E3647A-04D

S E R V I C E N O T E

E3647A DC Power Supply

Metal Strap Kit for tightening loose bumper and for fitting rear lock link in side-by-side rack mounting

Figure 2: Top view 3mm gap observed between two different chassis designs

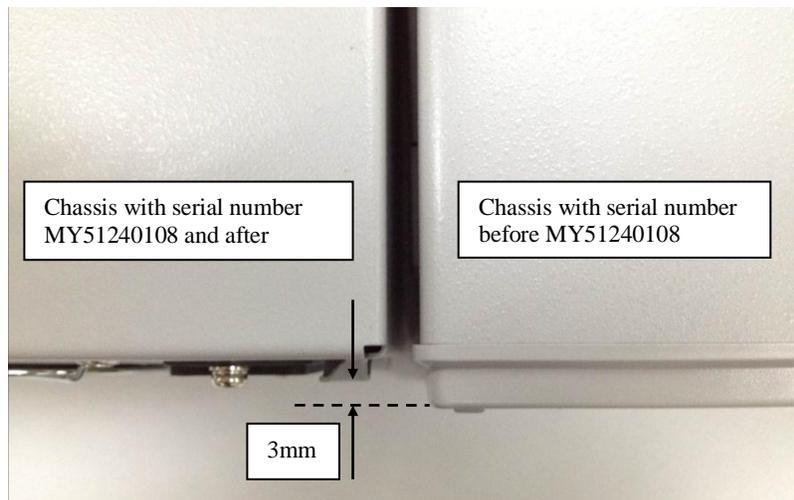
Situation 2:

The chassis depth difference between the two designs is 3mm as shown in Table 1 and Figure 2 below.

Figure 3: Top view 3mm gap observed on rear lock link for side-by-side rack mounting

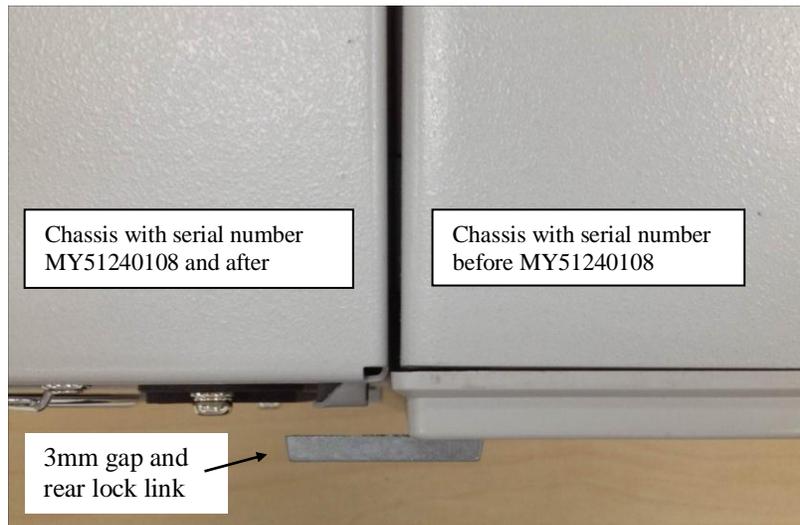
The 3 mm gap between the two different chassis may cause difficulties in securing them together using a rear lock link kit (part number 0050-2167) for side-by-side rack mounting as shown in Figure 3 below.

Solution for Situation 2

Use metal strap (part number E3631-07901), and stack the provided two metal straps together to form 3mm thickness and secure it with the provided screws on the rear lock link as shown in Figure 5 below.
